Access Compliance Report

Public Rights-of-Way

Intersection ID: 21206	Main Street: NORTHAMPTON_DR	Cross Street: PARK_RD	Location:	W
ADA ID: 7C7125AB0A7A	Ramp Type: PerpDiag	Initial Pass/Fail: Fail	Overall Compliance: No	Severity Score: 12.5

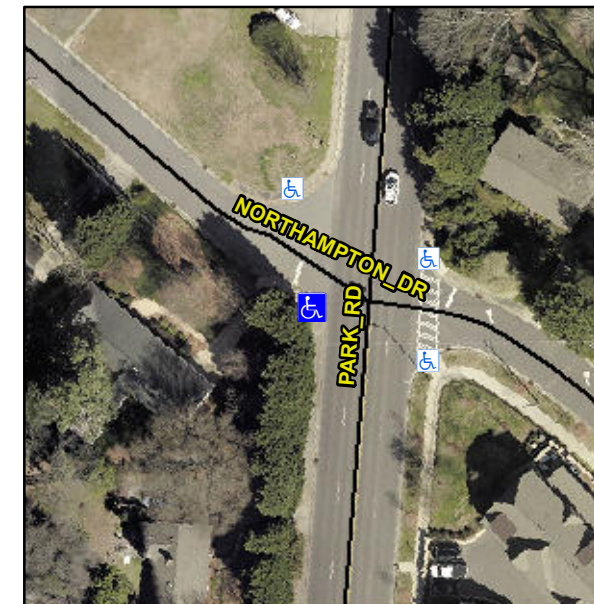
Not Found, R304.2.2

Compliance	Description	Data	Compliance	Description	Data
N/A	Ramp Length (in)	58.0	No	Ramp Slope (%)	8.5
Yes	Ramp Width (in)	48.0	Yes	Ramp XSlope (%)	1.9
N/A	Flare Type LT	N/A	N/A	Flare Type RT	N/A
N/A	Flare Slope LT (%)	N/A	N/A	Flare Slope RT (%)	N/A
N/A	Flare Traversable LT?	N/A	N/A	Flare Traversable RT?	N/A
N/A	Landing Length (in)	N/A	N/A	DWS Provided?	N/A
N/A	Landing Width (in)	N/A	N/A	DWS Contrast?	N/A
N/A	Landing Slope (%)	N/A	N/A	DWS Length (in)	N/A
N/A	Landing X Slope (%)	N/A	N/A	DWS Full Width?	N/A
N/A	Landing Curb? (Y/N)	N/A	N/A	DWS Offset (in)	N/A
N/A	Shared Landing?	N/A			
N/A	Gutter Ponding?	N/A	N/A	Gutter Slope (%)	N/A
N/A	Gutter Lip Ht (in)	N/A	N/A	Gutter X Slope (%)	N/A
N/A	Painted X Walk1?	No	N/A	Painted X Walk2?	No
	X Walk 1 Direction	To SE		X Walk 2 Direction	To N
N/A	X Walk 1 Width (in)	N/A	N/A	X Walk 2 Width (in)	N/A
	X Walk 1 Slope (%)	1.2		X Walk 2 Slope (%)	1.4
	X Walk 1 X Slope (%)	1.9		X Walk 2 X Slope (%)	0.4

Remove & Replace Curb Ramp With Two New Directional Ramps or Equivalent.
